ADDENDUM #2

ISSUED BY EDiS COMPANY
110 S. POPLAR STREET, WILMINGTON, DE 19801

RED CLAY CONSOLIDATED SCHOOL DISTRICT
A. I. DuPont Middle School
HVAC RENOVATION
3130 KENNETT PIKE
WILMINGTON, DELAWARE 19807

1 PARTIAL FIRST FLOOR PLAN - AREA A -1/A3.3
 SK-A.32 3/32" = 1'-0"

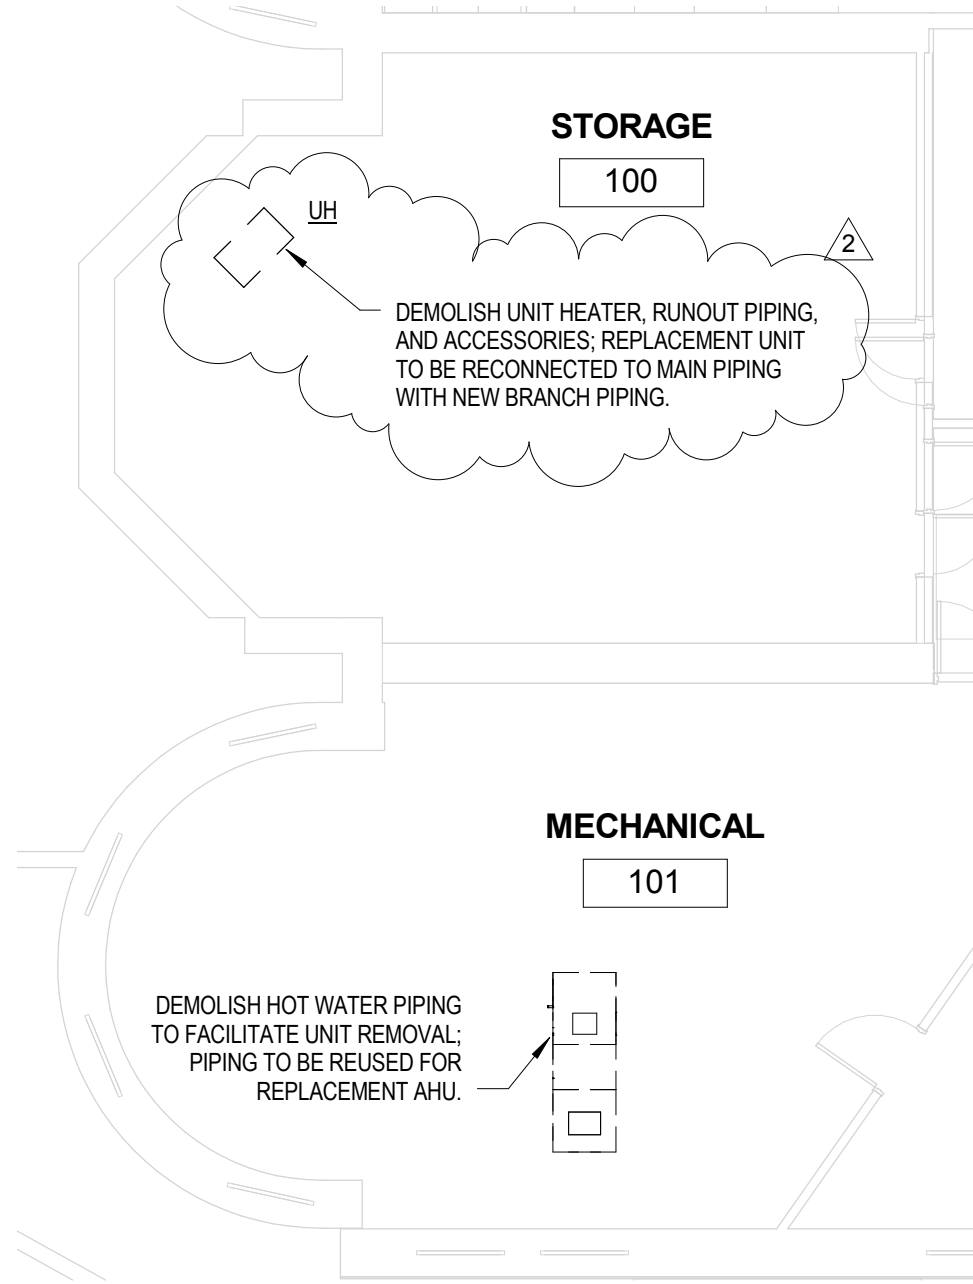
Answer: See attached sketch SK-A.32 for location and quantity of manual bleachers. See attached revised specification section 12 66 13.
29. **Question:** Drawing A-3.4 Note 4: This note reference a new ADA platform lift. Is there any electrical associated with this lift. There is nothing shown on the power plans.

1 PARTIAL BOILER ROOM HYDRONIC PLAN
SK-M.21 1/4" = 1'-0"

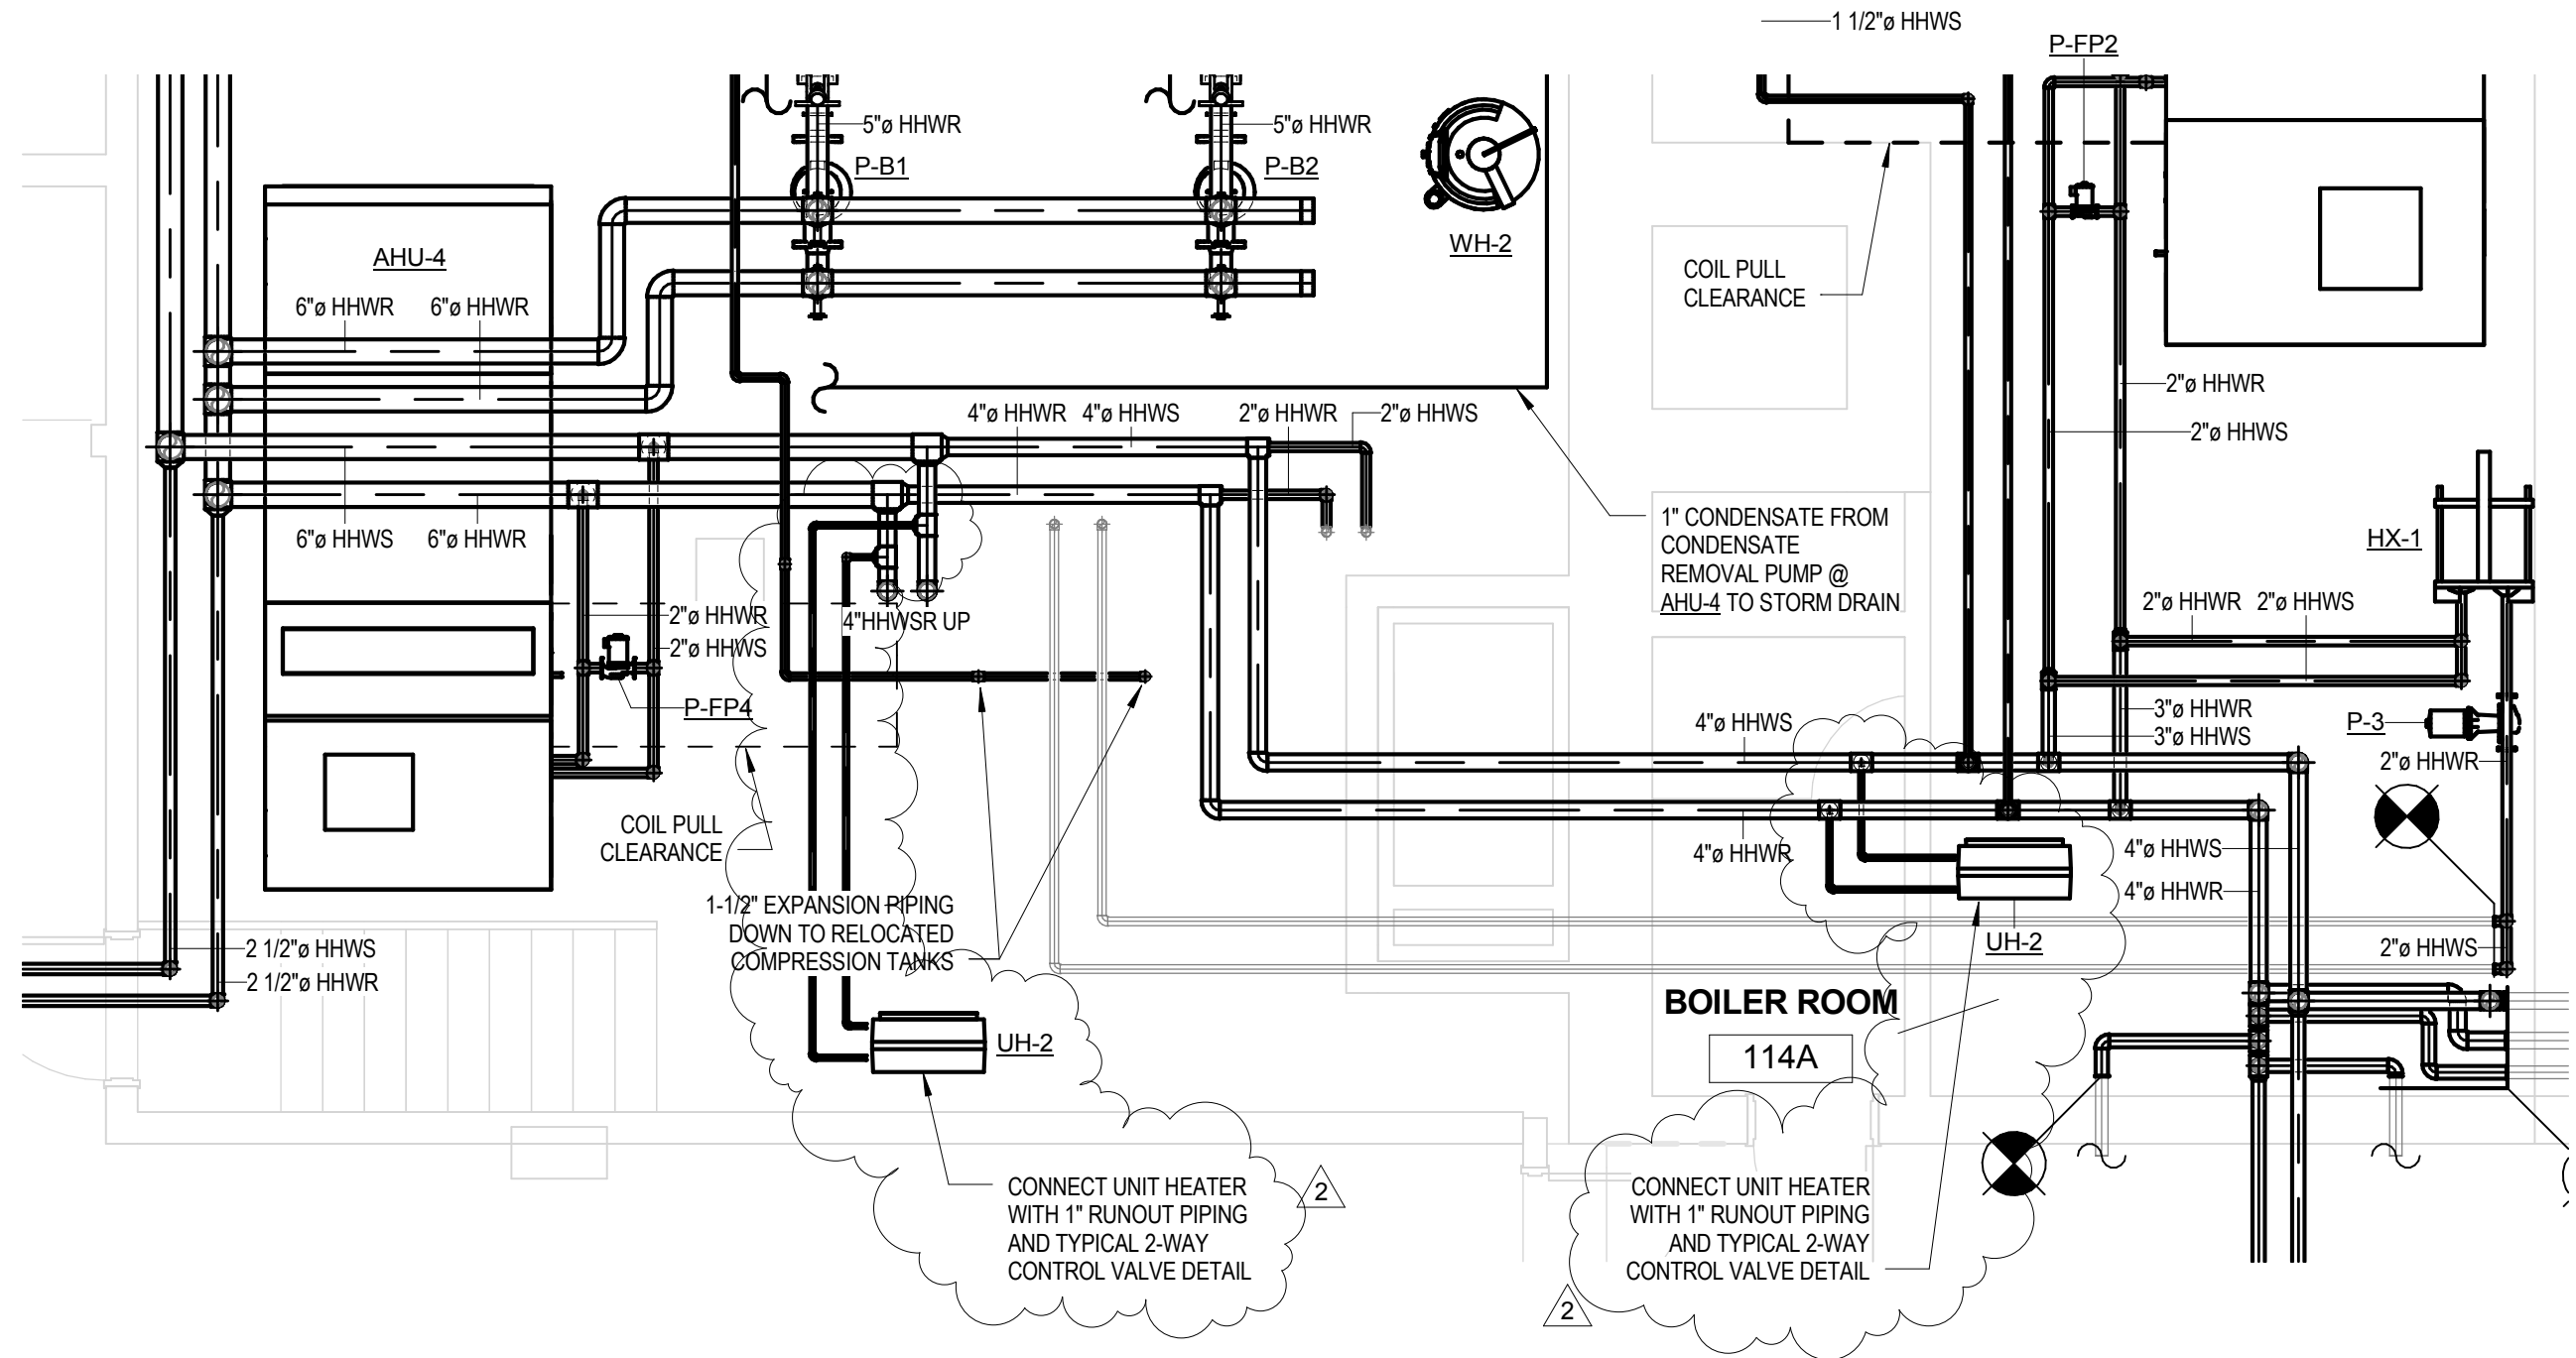
1. Drawing M8.18 – Sheet is re-issued. See attached revised M8.18. Add note to coordinate ductwork with attic duct routing. Move note that indicates where ductwork goes up into attic.
2. Drawing M8.7 – Add unit heater demolition. See sketch SK-M.18.
3. Drawing M8.20 – Add unit heaters & piping. See sketch SK-M.19.
4. Drawing M8.29 – Add unit heater schedule and schedule notes. See sketch SK-M.20.
5. Drawing M8.27 – Add unit heaters and piping. See sketch SK-M.21.

E9.10
SHEET NO.
SK-E.12

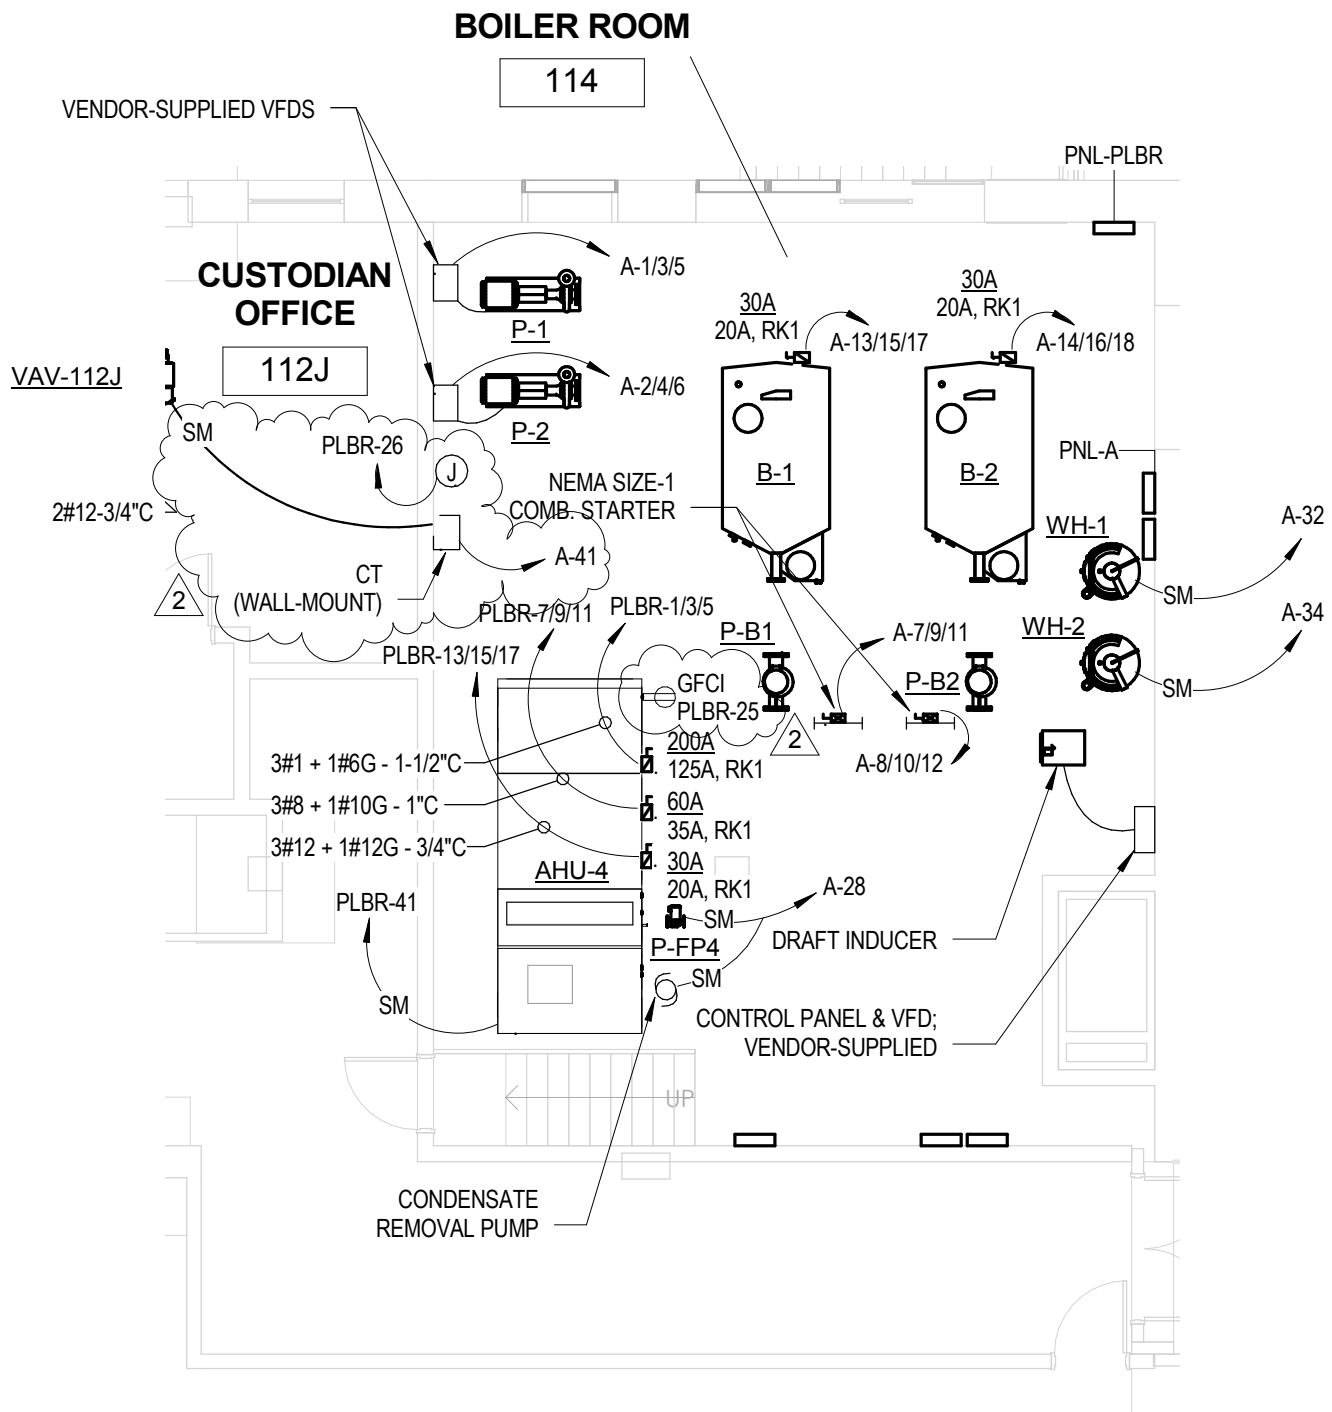
4. Drawing SK-E.11 – Added circuit designation to panel PL2A for receptacles on roof to CUs.
5. Drawing E9.10 – Add GFCI receptacle at AHU-4. Add junction box for ATC power supply. Move CT location from ceiling to boiler room as indicated. See sketch SK-E.12.

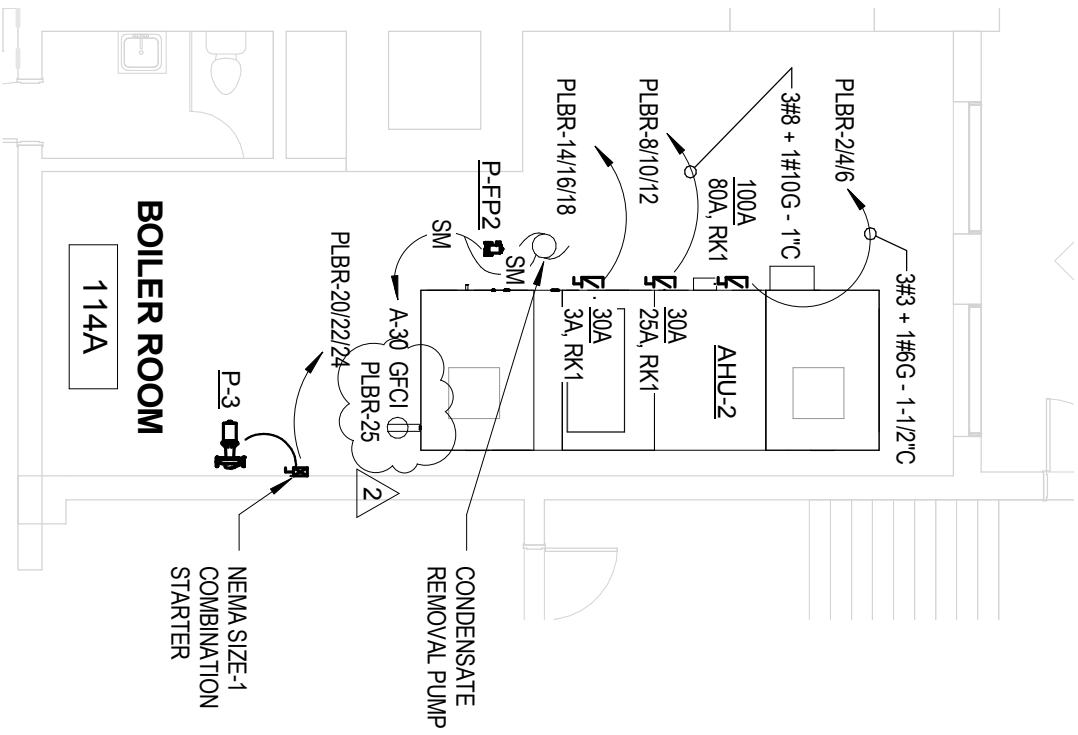
6. Drawing E9.23 – Revise schedule for PNL-PLBR. See sketch SK-E.13.
7. Drawing E9.11 – Add GFCI receptacle at AHU-2. See sketch SK-E.14.
8. Drawing E9.11 – Move CT from ceiling space to Storage 115B. See sketch SK-E.15.

E9.11
SHEET NO.
SK-E.16

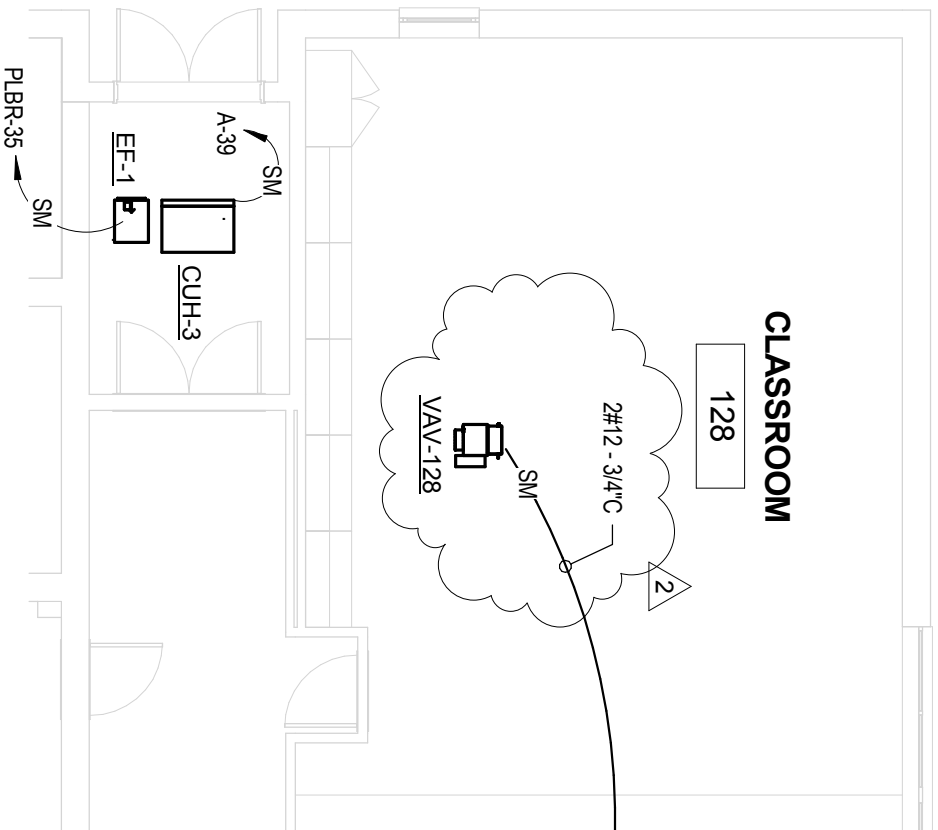
9. Drawing E9.11 – Delete CT at Classroom 128. See sketch SK-E.16. Delete associated ckt 42 from PNL-A (no sketch issued to reflect change to panel schedule).
